Re: Power Workers Union and Hydro One Networks Inc. – Transmission Line between Thunder Bay and Wawa, Ontario EB-2017-0182/EB-2017-0194/EB-2017-0364

Application for leave to construct an electricity transmission line

Power Workers' Union Interrogatories to Hydro One Networks Inc.

Ref: Ref: Addendum to 2017 Updated Assessment for the Need for the East-West Tie Expansion, Page 6

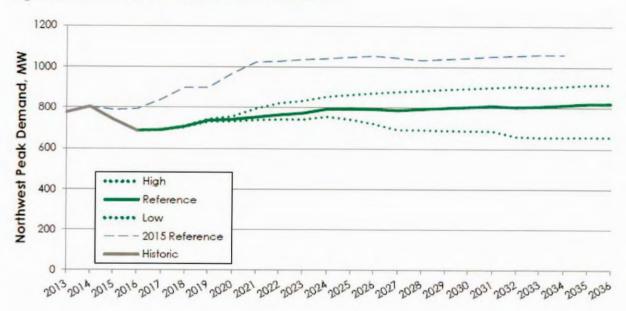
a) From Hydro One's perspective, what are the potential reliability impacts of delaying the project?

- b) What, if anything, can Hydro One do to minimize the impact on reliability?
- c) Does Hydro One agree that the risks to system reliability of delay beyond 2022 are "unacceptable"?
